Amendments to Findings Statement  
for  
Ferry Landings  
(adopted February 6, 2006)

Ferry Landings

West Main Street, Village of Tarrytown, Westchester County, New York  
Tax Map Sheet 1, Block 0000, Parcels 13, 14, 15, 20, 21, 23, 24, and 24A

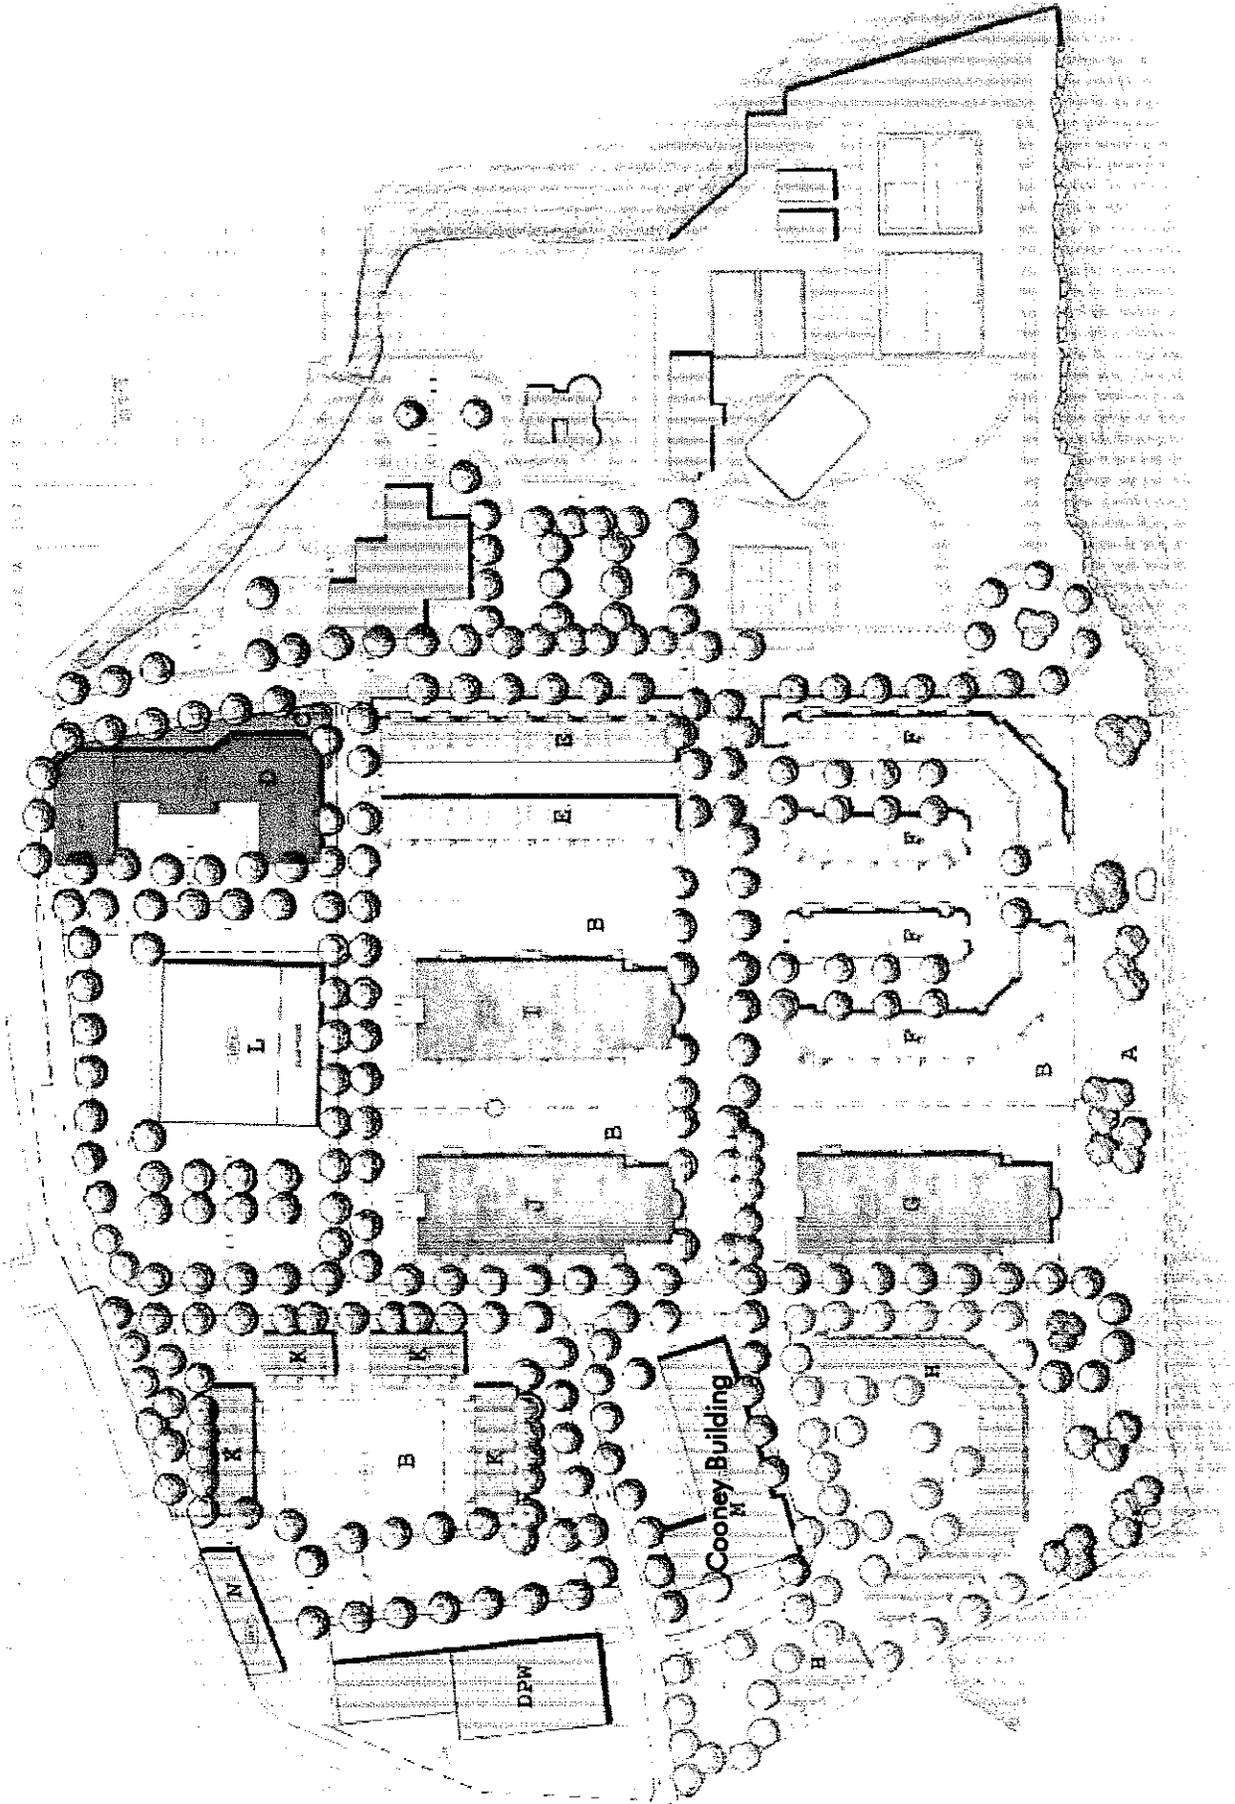
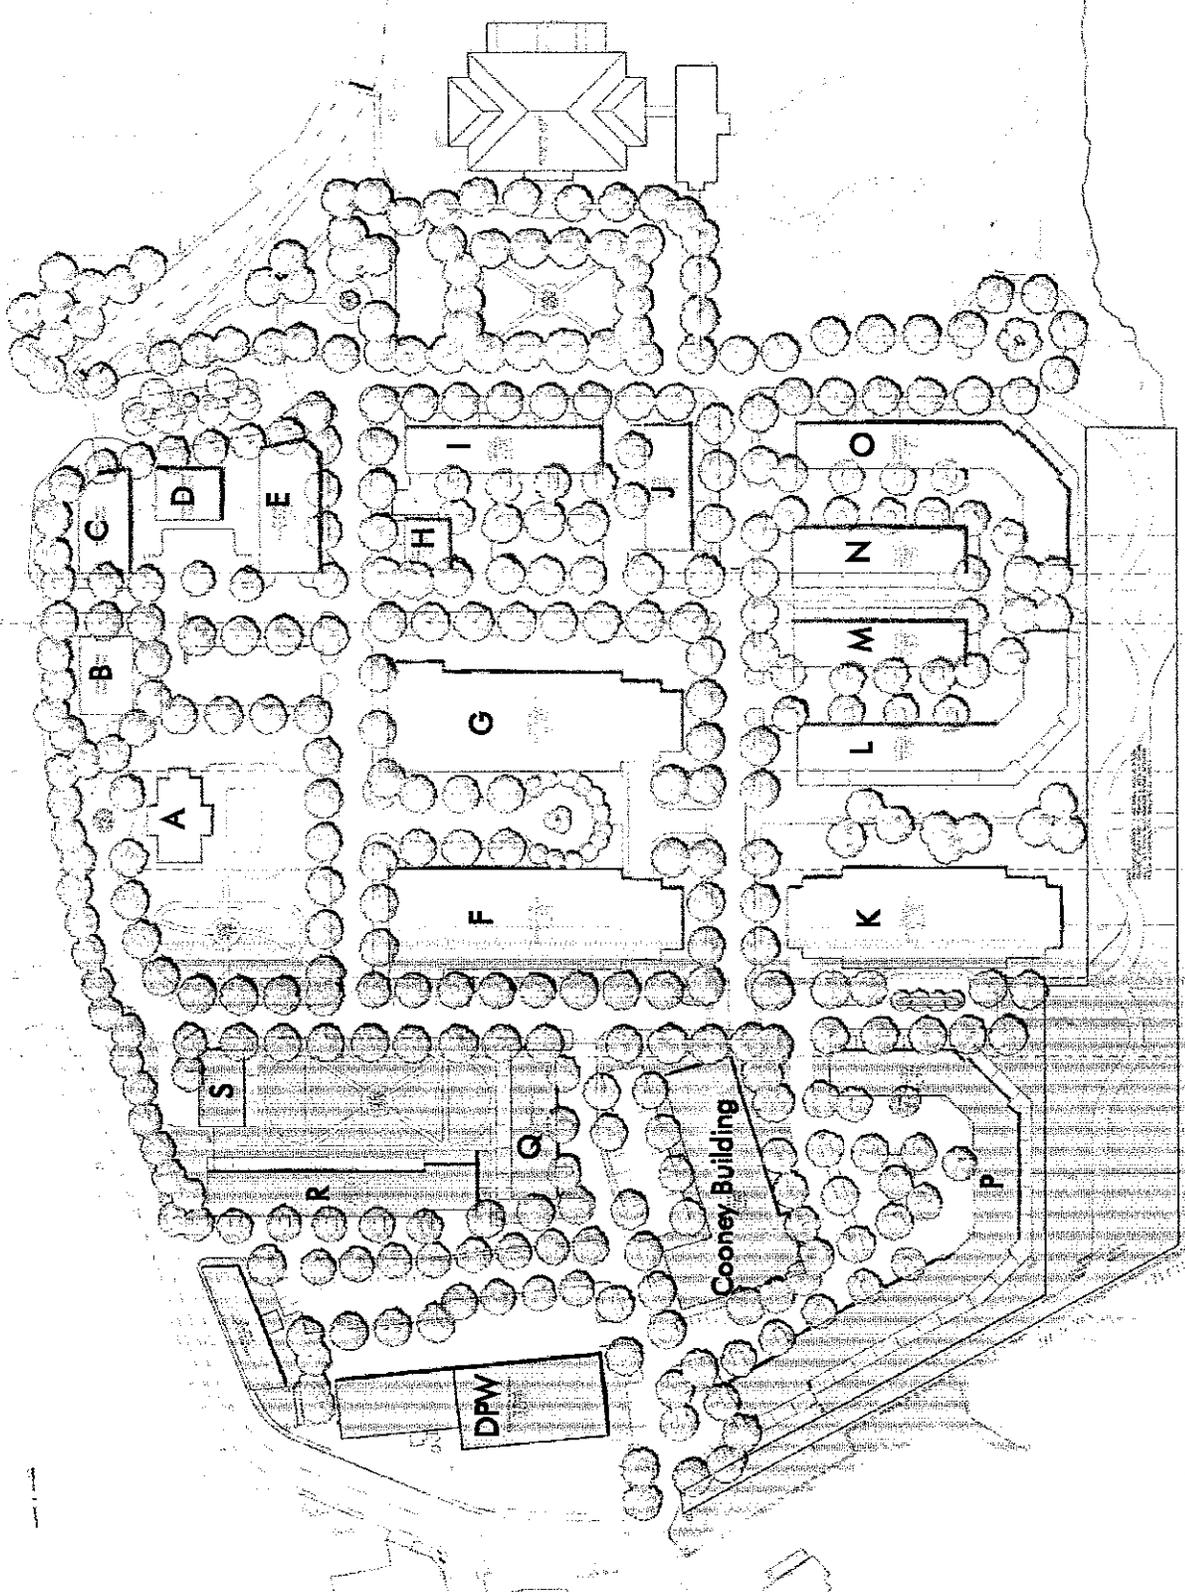
Since the adoption of the Findings Statement for Ferry Landings on February 6, 2006, the applicant has been working with the Village Planning Board to refine the site plan for approval. Through this process, some changes have been made to the site plan layout in order to enhance the site design and respond to comments made by the Planning Board and the Architectural Review Board. The site plan upon which the Findings Statement was based is shown in Figure 1 and the revised site plan is shown in Figure 2. The changes that have been made to the Findings Statement site plan (Figure 1) are as follows:

- *Elimination of Building D from the site plan shown in Figure 1.*  
This building was proposed as a mixed use office/retail building on the original site plan, but has now been removed from the plan. It was determined that this structure did not provide for an attractive entrance into the site and that it should be eliminated. As shown in Figure 2, this portion of the site now includes a one-story 5,000 square foot retail building, a two-story 6,000 square foot retail building, and a three-story building with 15 residential units.

- *Removal of Building L from the site plan shown in Figure 1.*  
This existing building, shown as Building L on the original site plan and referred to as the "blue building/Penske building," has been removed from the plan. The revised site plan provides for a one-story 4,400 square foot retail building, a 4,200 square foot clubhouse and 40 x 80 foot outdoor swimming pool for Ferry Landings residents on this portion of the site.

- *Reconfiguration of the two residential buildings on West Main Street, designated as "E" on the site plan shown in Figure 1.*  
This portion of the site has been reconfigured in response to comments that the proposed buildings were too long and would create a wall along West Main Street. Shown on Figure 2, the units have been rearranged in order to break up this "wall" and a courtyard has been created in this area.

- *Reconfiguration of the residential units on the northeast portion of the site, designated as "K" on the site plan shown in Figure 1.*  
Units on this portion of the site have been reoriented to face south.

- *Reconfiguration of the residential units on the northwest portion of the site, designated as "H" on the site plan shown in Figure 1.*  
The two smaller buildings that were shown in this location are now shown as one building.
